Access Compliance Report Public Rights-of-Way (Curb Ramps)

Intersection ID: 32288 Main Street: OLD_ARDREY_KELL_RD Cross Street: ALLYSON_PARK_DR Location: NW

ADA ID: E98A07EDE9E5 Ramp Type: Perp Initial Pass/Fail: Fail Overall Compliance: No Severity Score: 13.75

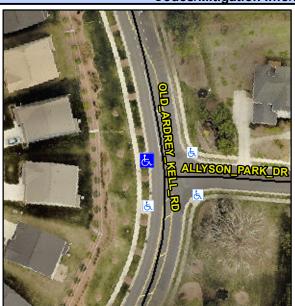
R304.2.2

Comp	liance Description	Data	Comp	liance Description	Data
N/A	Ramp Length (in)	94.0	No	Ramp Slope (%)	9.4
Yes	Ramp Width (in)	51.0	Yes	Ramp XSlope (%)	2.3
N/A	Flare Type LT	N/A	N/A	Flare Type RT	N/A
N/A	Flare Slope LT (%)	N/A	N/A	Flare Slope RT (%)	N/A
N/A	Flare Traversable LT?	N/A	N/A	Flare Traversable RT?	N/A
N/A	Landing Length (in)	N/A	N/A	DWS Provided?	N/A
N/A	Landing Width (in)	N/A	N/A	DWS Contrast?	N/A
N/A	Landing Slope (%)	N/A	N/A	DWS Length (in)	N/A
N/A	Landing X Slope (%)	N/A	N/A	DWS Full Width?	N/A
N/A	Landing Curb? (Y/N)	N/A	N/A	DWS Offset (in)	N/A
N/A	Shared Landing?	N/A			
N/A	Gutter Ponding?	N/A	N/A	Gutter Slope (%)	N/A
N/A	Gutter Lip Ht (in)	N/A	N/A	Gutter X Slope (%)	N/A
N/A	Painted X Walk1?	No	N/A	Painted X Walk2?	N/A
	X Walk 1 Direction	То Е		X Walk 2 Direction	N/A
N/A	X Walk 1 Width (in)	N/A	N/A	X Walk 2 Width (in)	N/A
	X Walk 1 Slope (%)	5.1		X Walk 2 Slope (%)	N/A
	X Walk 1 X Slope (%)	3.2		X Walk 2 X Slope (%)	N/A

Remove & Replace Entire Ramp.
